Date: August 15, 2018
To: Cumberland Planning Board
From: Carla Nixon, Town Planner
Subject: OceanView at Cumberland Major Subdivision Final Review

Date August 15, 2018
To Town of Cumberland Planning Board
From Carla Nixon, Town Planner
Subject **Major 52 Unit Major Subdivision, Final Review: OceanView at Cumberland – 277 Tuttle Road**

Subject: Planner's Comments for Ocean View

FIELD WK:	SCALE:	SHEET: C20
DRN BY:	JOB #: 109	
CH'D BY:	SS:	
DATE: 6-15-2018	FILE:

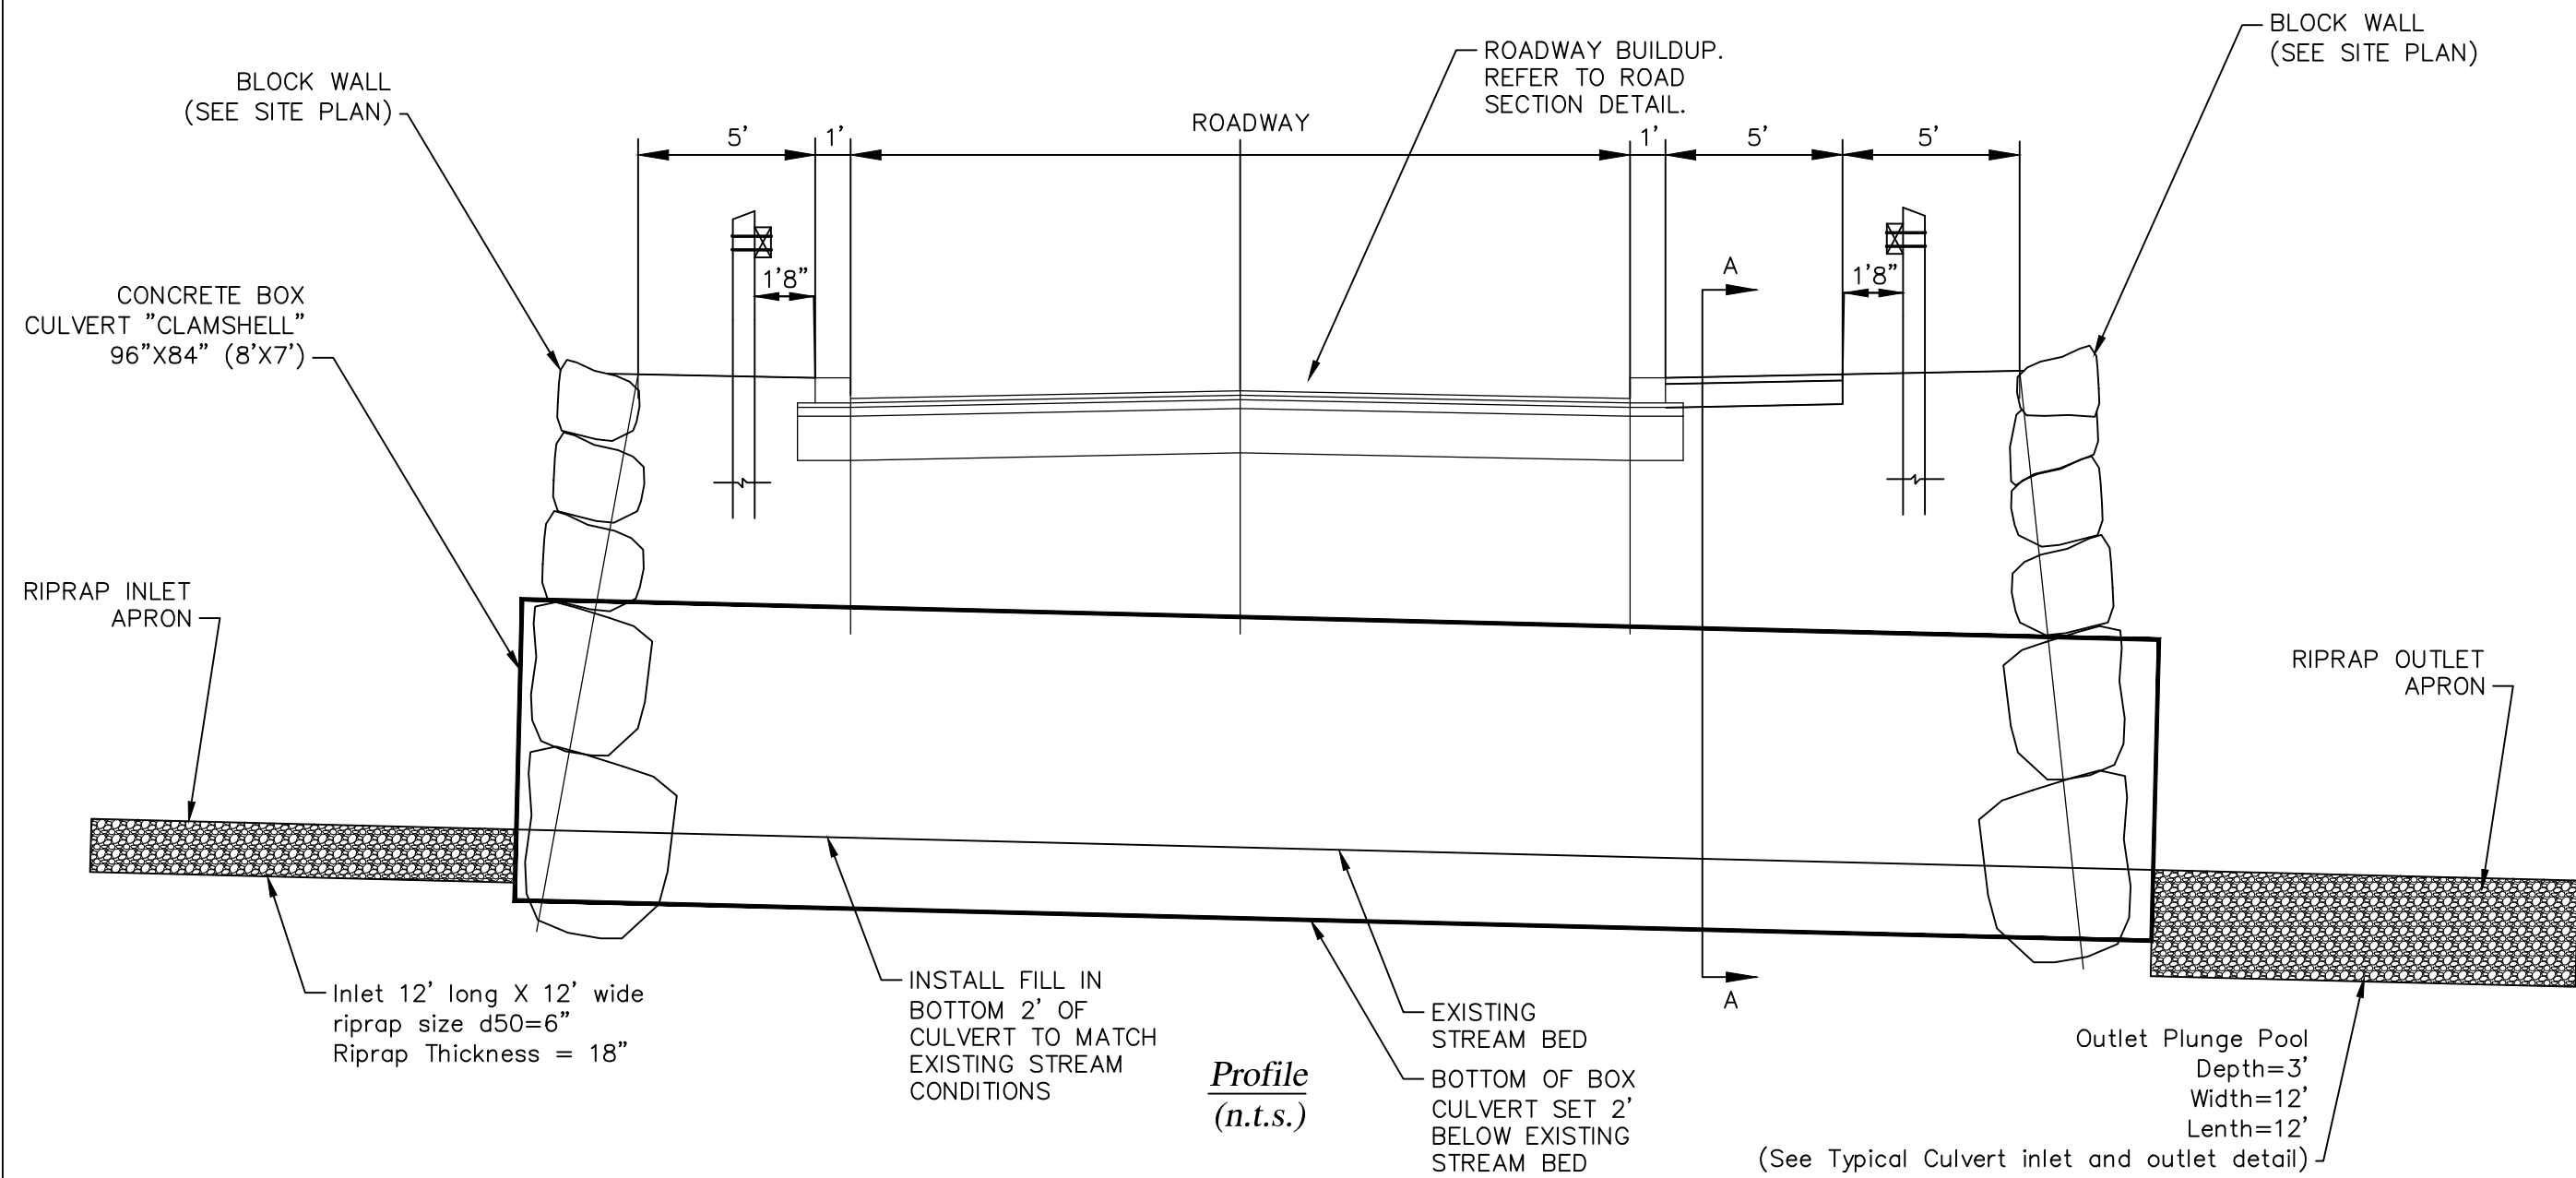
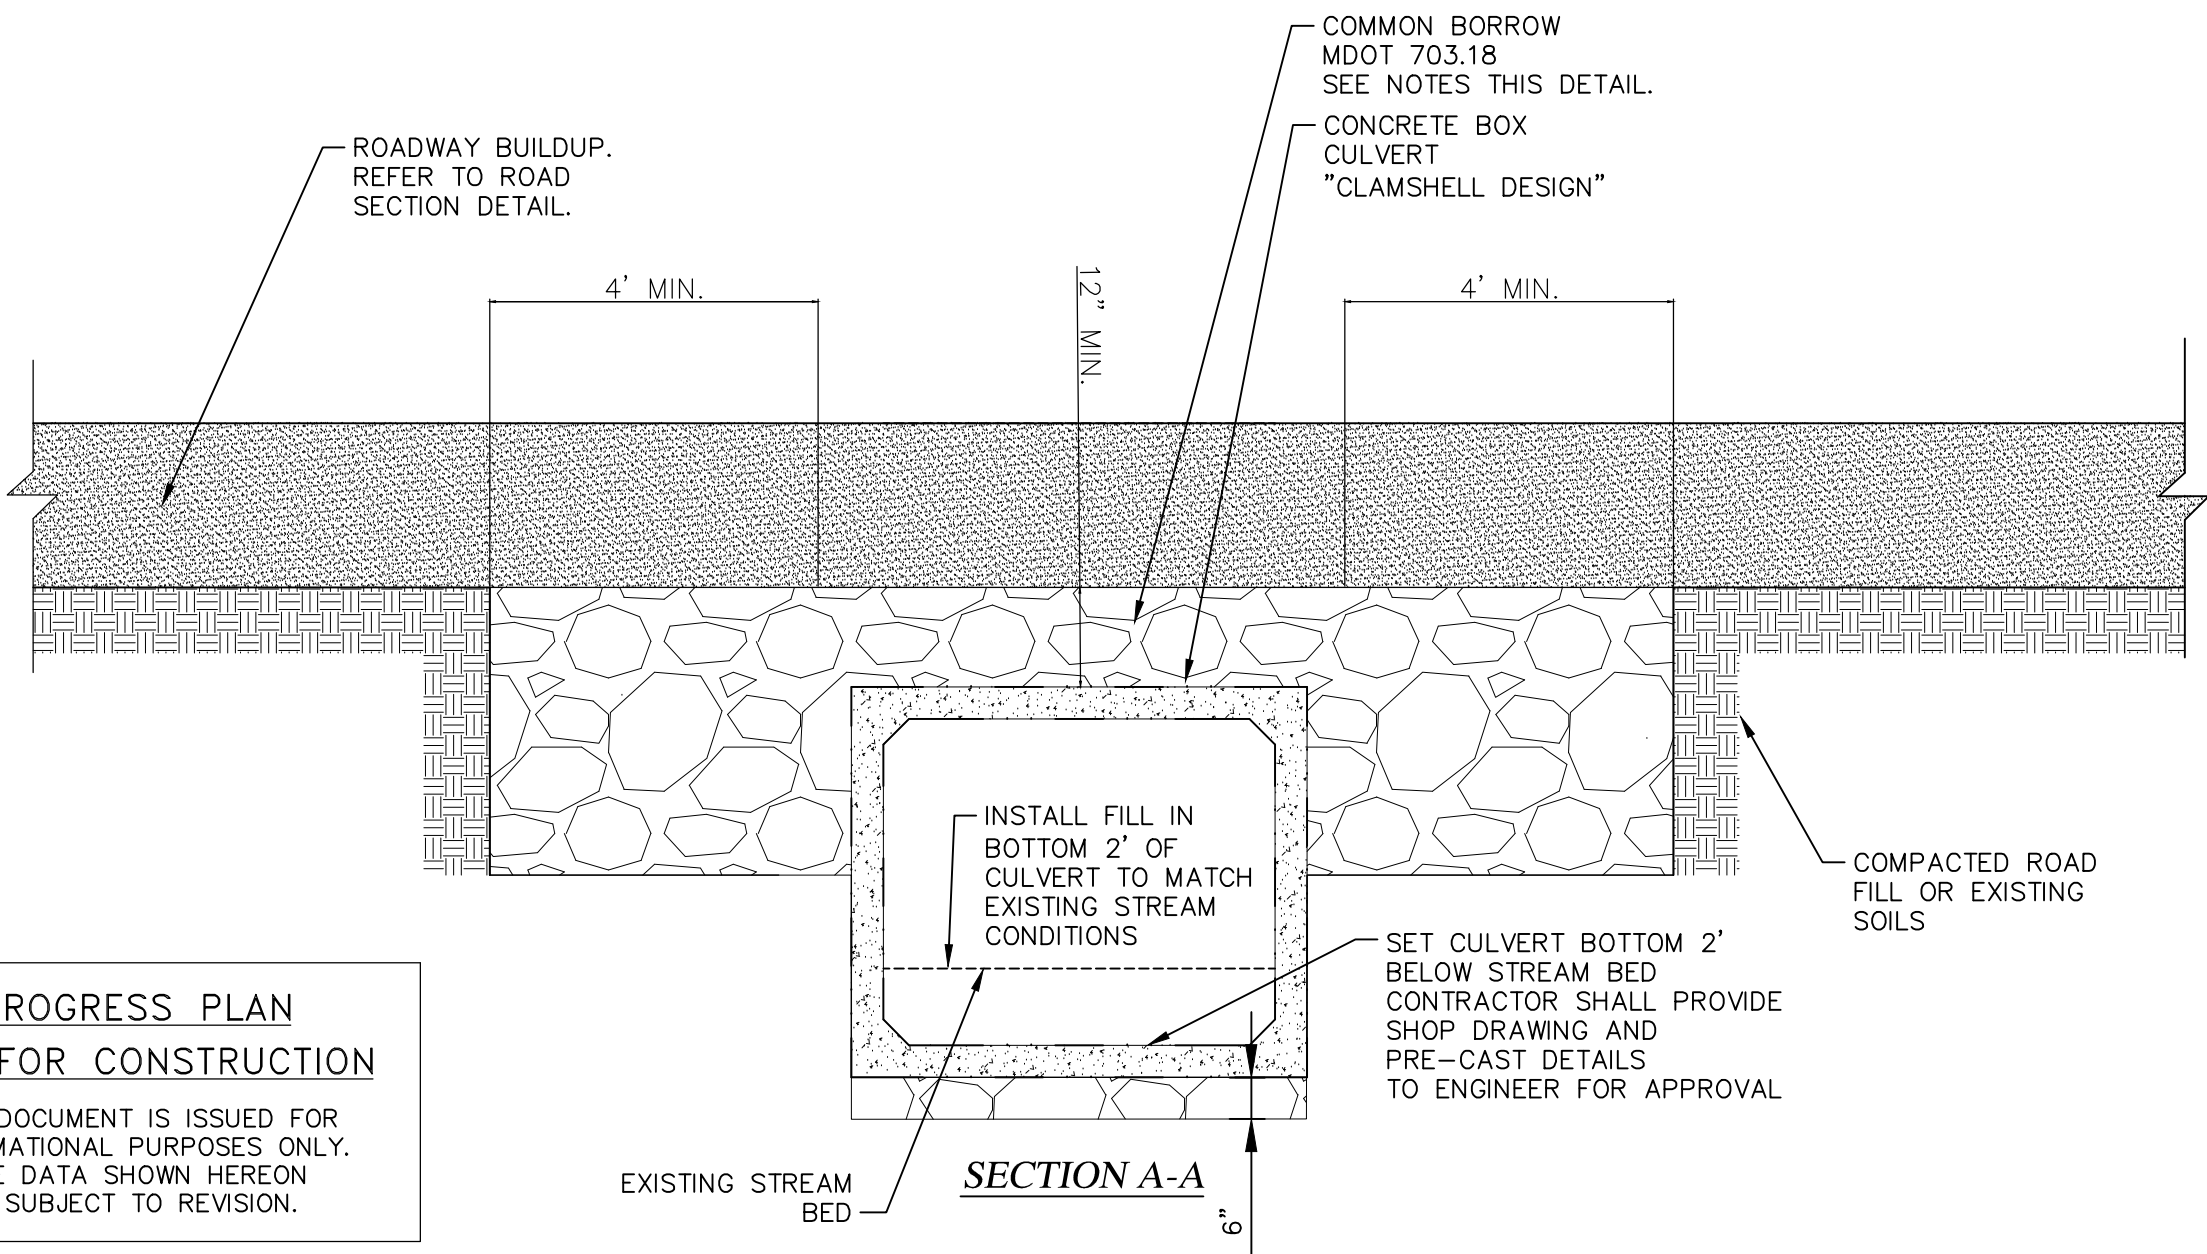
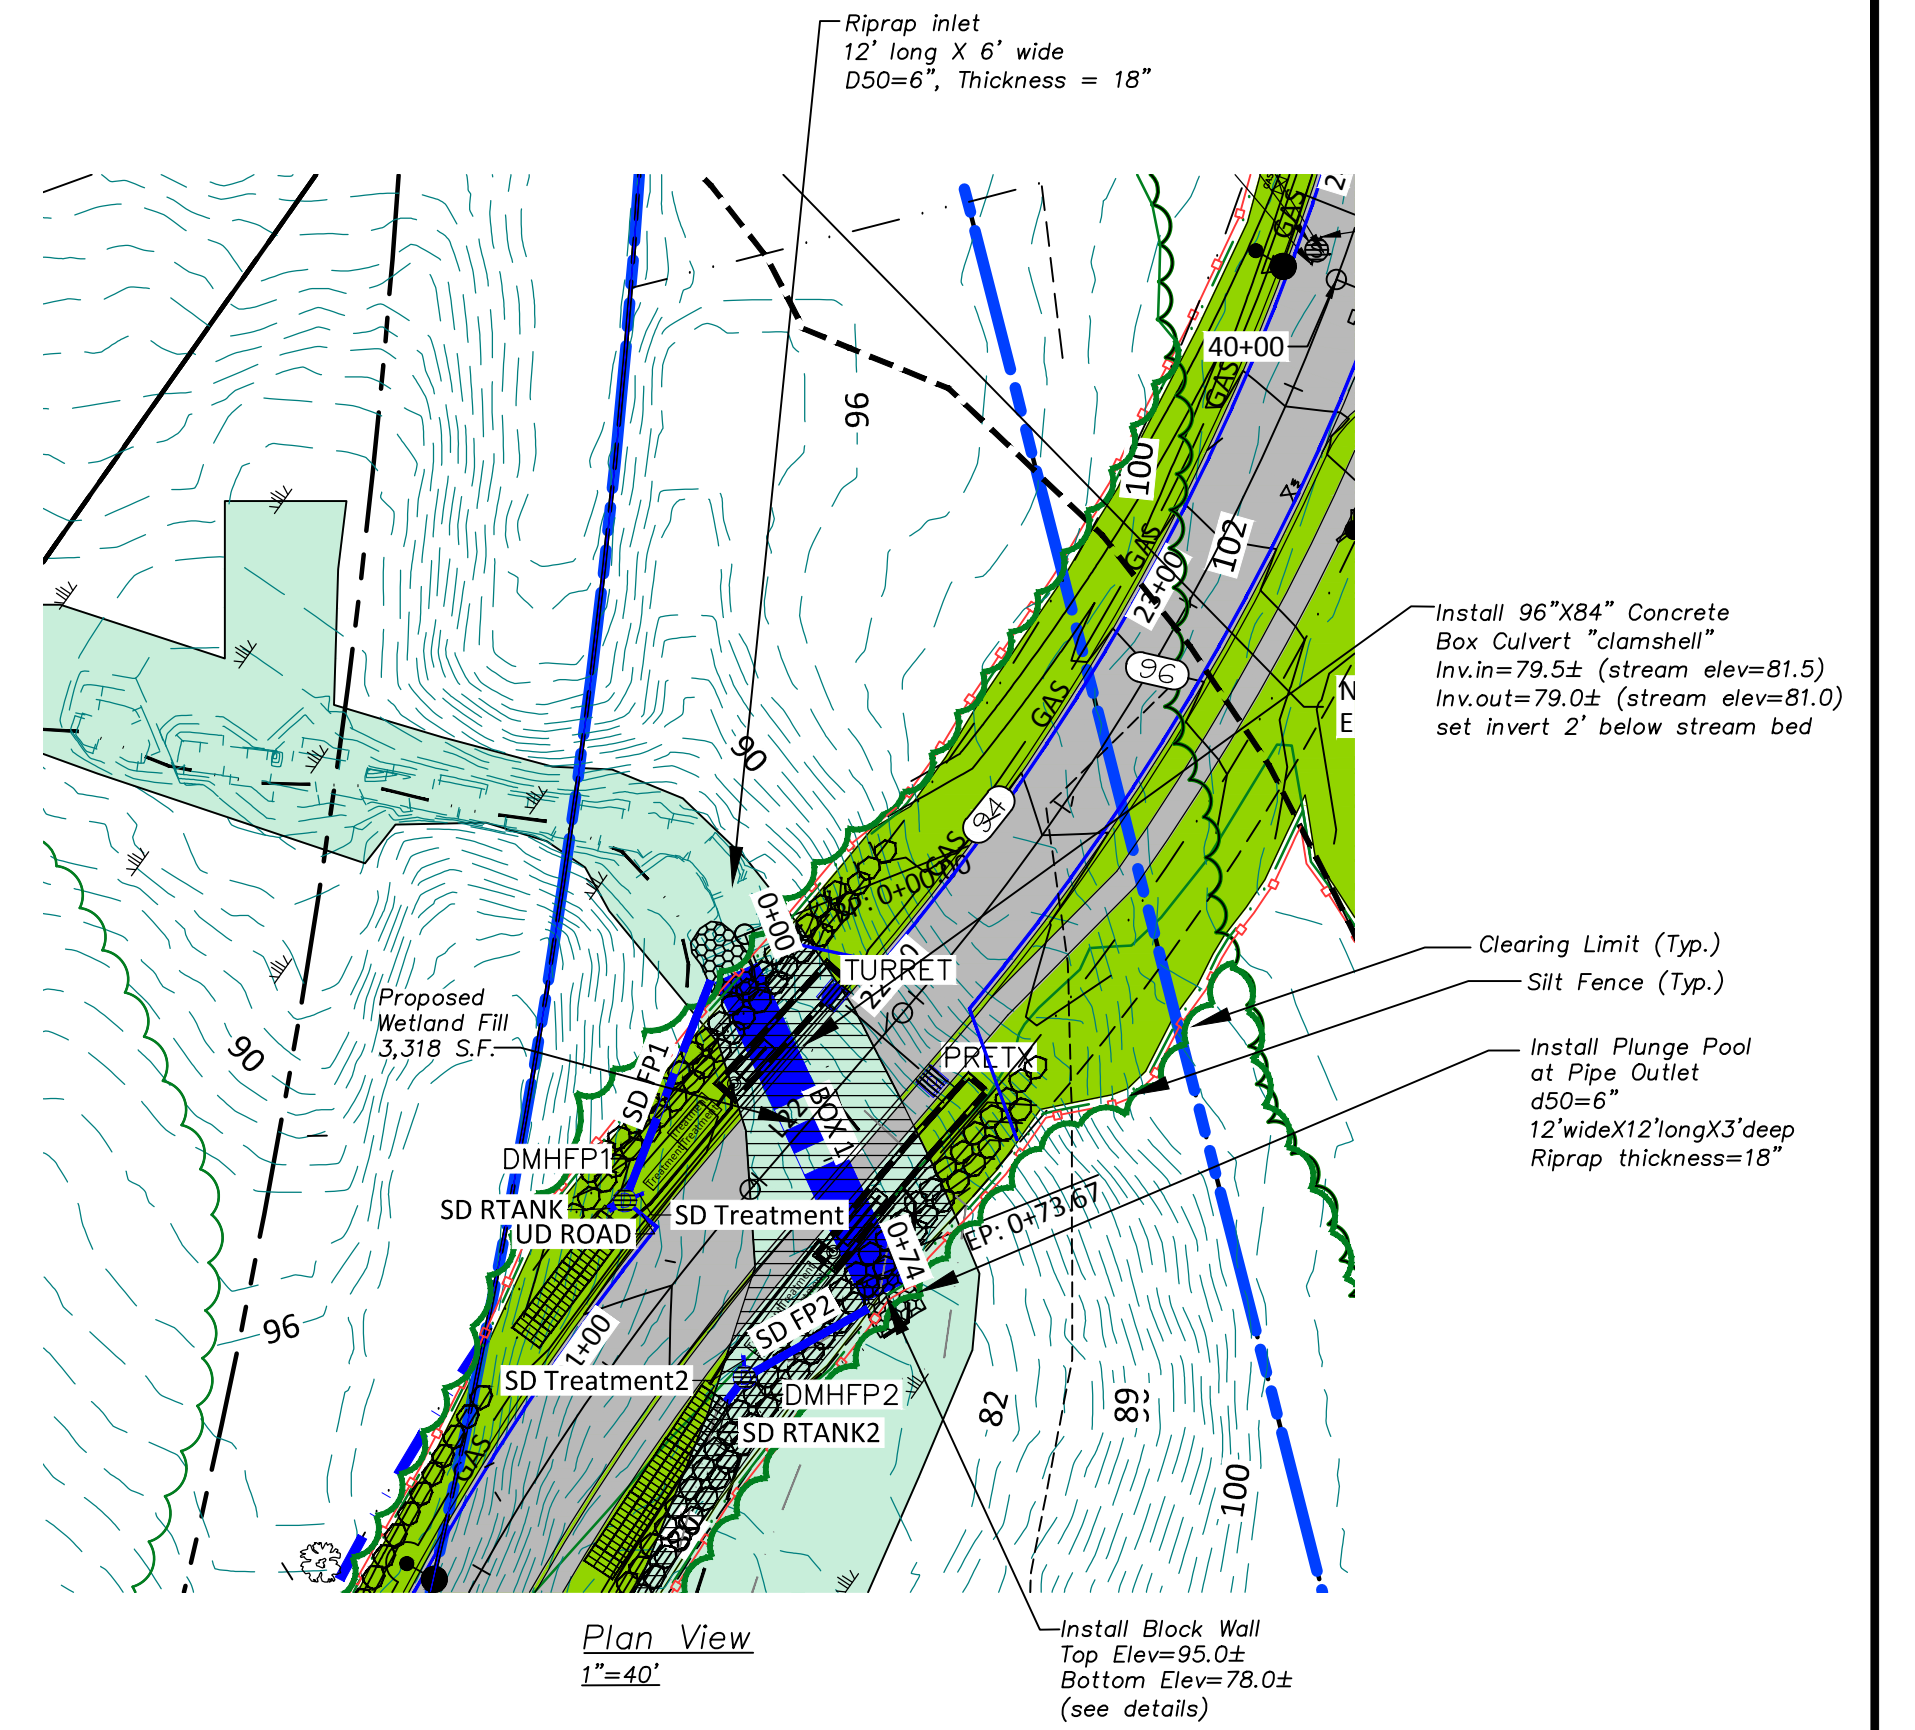
- Sheet C20 – The end view is of Box Culvert #2 not Box Culvert #1.

We have updated the end view on sheet C20.
